# *SILVER BOW CREEK INVESTIGATION*

RESPONSES TO COMMENTS RECEIVED FROM  
ARCO COAL COMPANY ON THE WARM SPRINGS  
PONDS PHASE II REMEDIAL INVESTIGATION  
DATA SUMMARY REPORT

CH2M HILL, Inc.  
Helena, Montana

December, 1990

**ELECTROMAGNETIC ISOLINE MAP**  
OF THE AREA BELOW POND 1

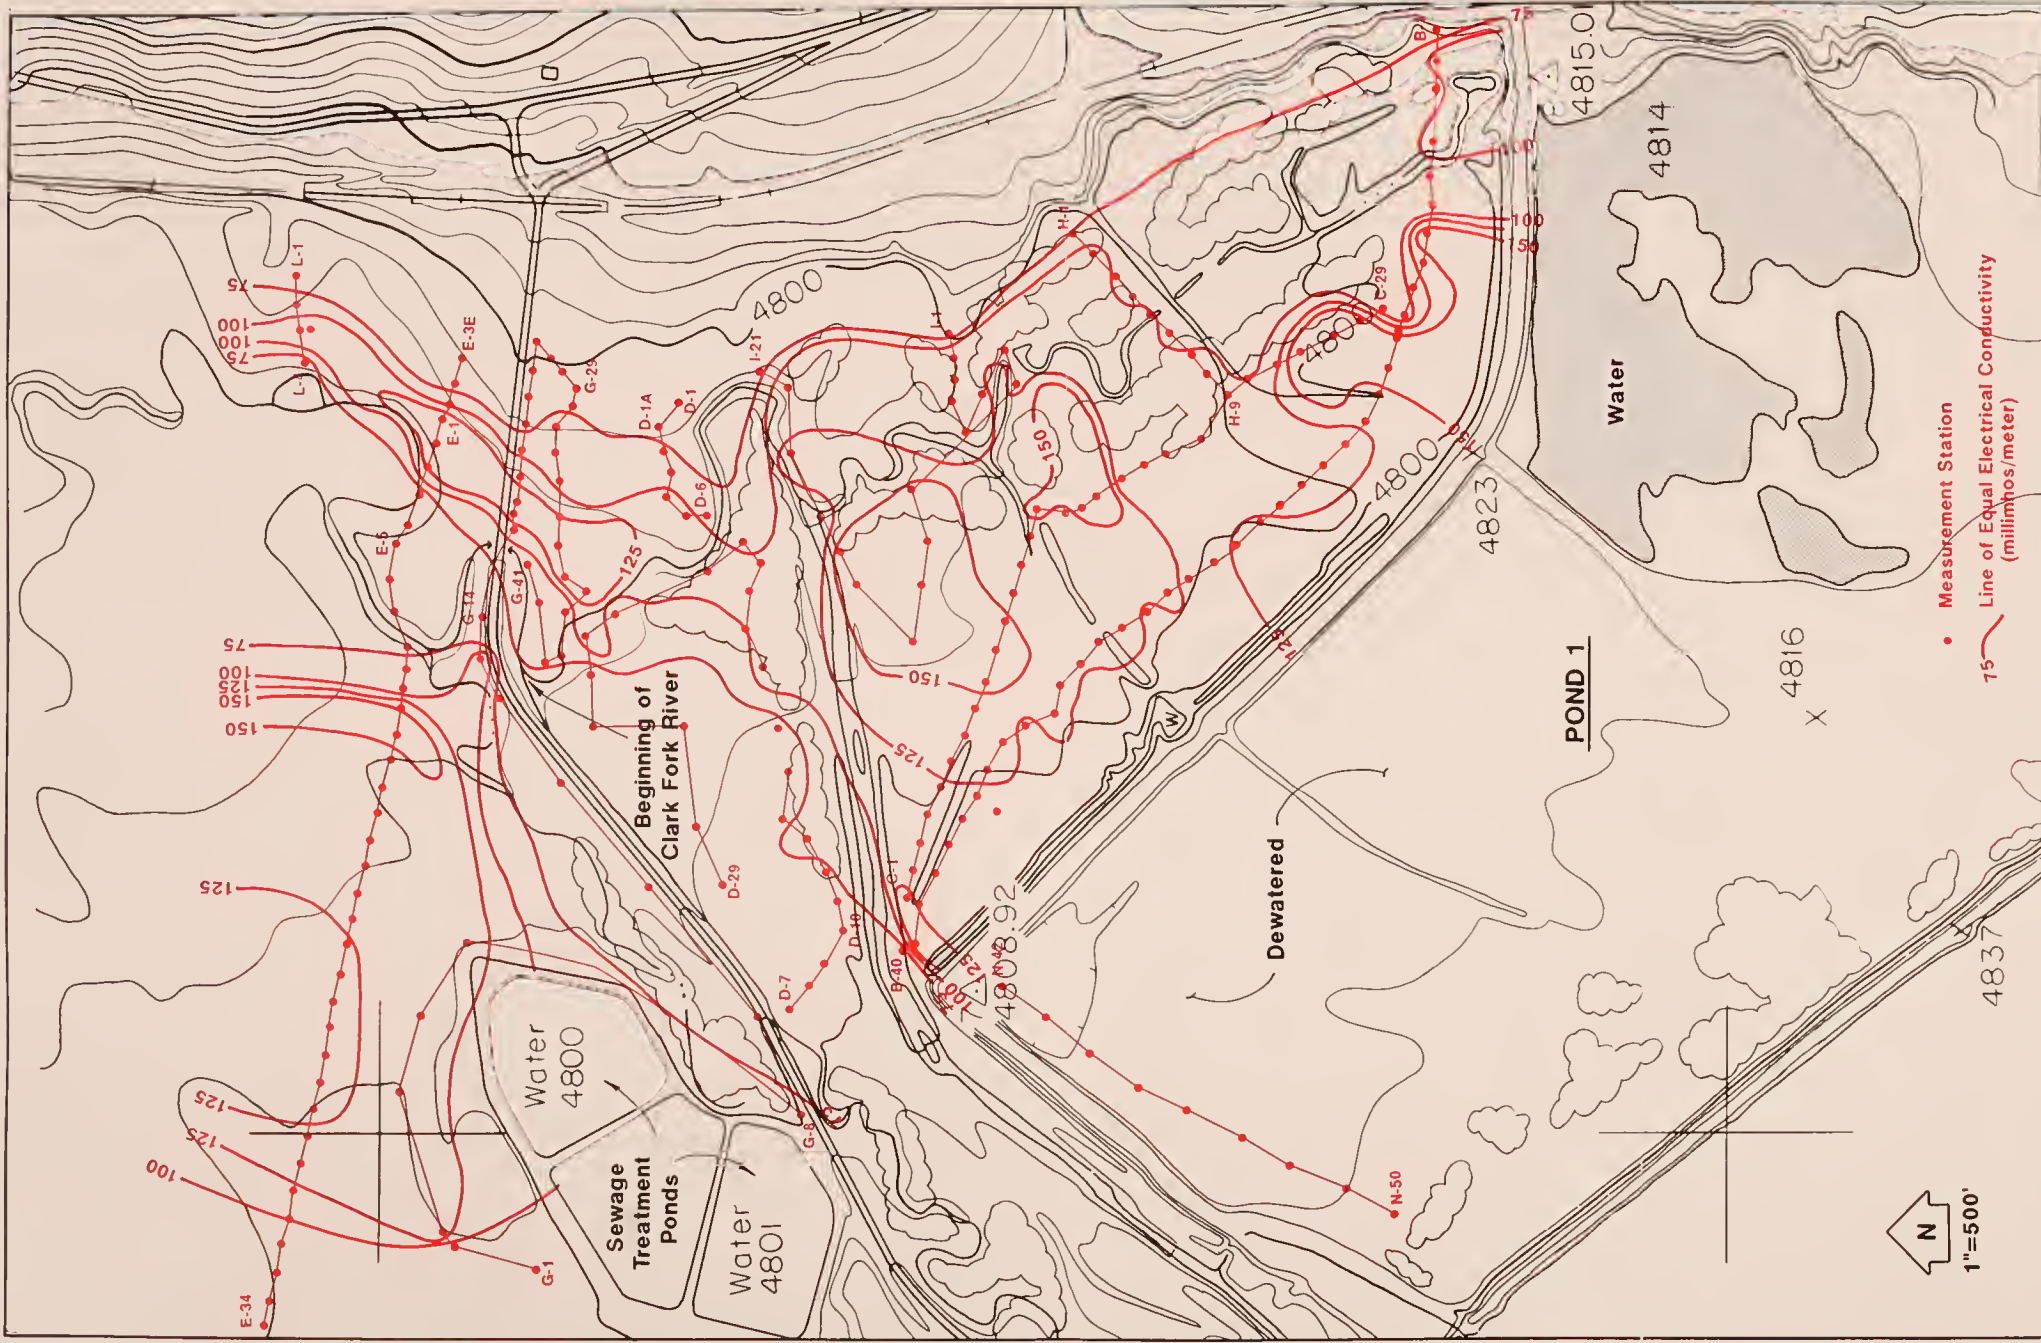
5. *The EM survey results appear to indicate three distinct areas of shallow terrain exhibiting relatively high field conductivity downstream of Pond 1 (Figure 3-2). A comparison of EM data with the measured specific conductance of groundwater sampled from the monitoring wells should have been made. This would have allowed a more meaningful evaluation of the measured specific conductance of shallow groundwater.*

Response: Although specific electrical conductivity data for groundwater samples obtained in the area downgradient of Pond 1 were not plotted and presented as a figure in the Phase II RI report, manganese and sulfate data were presented. Manganese and sulfate concentrations measured in wells completed in the shallow sand and gravel aquifer downgradient of Pond 1 (Figures 3-10 and 3-11, Phase II RI report) correlate well with EM survey data. Our review of Figures 3-10 and 3-11 indicates that manganese and sulfate concentrations measured in monitoring wells

completed immediately below the Pond 1 berm (WSP-GW-02, -03, -13, and -19) were relatively higher than concentrations for those parameters measured in other monitoring wells. These wells are all located within the EC contour lines of 125 millimhos/meter or higher as depicted on Figure 3-3.
